FINAL
NAVAL AIR STATION ALAMEDA RESTORATION ADVISORY BOARD
MEETING SUMMARY

November 2, 2006

Summary of Comments on Draft Feasibility Study IR Site 2, West Beach Landfill and Wetlands, Alameda Point, California

TAPP GRANT PRELIMINARY REVIEW ON PROPOSED PLAN FOR IR SITE 1

Soil Alternative 2

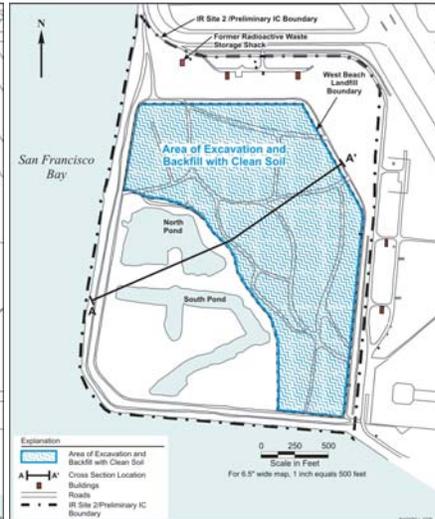
Slide 19 showed a map of the footprint used for soil Alternative 2, which is slightly larger than the footprint for Alternative 6. Mr. Humphreys asked about the radioactive waste sites near the top of the maps and outside of the footprints. Mr. Williamson noted that these sites would be addressed in the proposed time-critical removal action (TCRA) but he did not believe that solvents had been detected in

• The landfill cap uses an inadequate “footprint” and must define and include all waste and impacted soil areas.

1. The soil cover does not address higher subsurface contamination and does not protect groundwater, which discharges to surface water.
2. Dredge fill material, if used, must be certified as clean (well below “background,” which is actually quite high based on the statistics used to determine it).
3. The engineered cover will most likely be a prescriptive cover (with low-permeability layer) in accordance with California regulations. The proposed alternative may not be the best or most cost-effective. Additional design criteria need to be provided in the FS to support the effectiveness evaluation. An engineered cover would address groundwater/surface water impact and reduce ecological risk to birds in wetland ponds that were identified in the Remedial Investigation document.
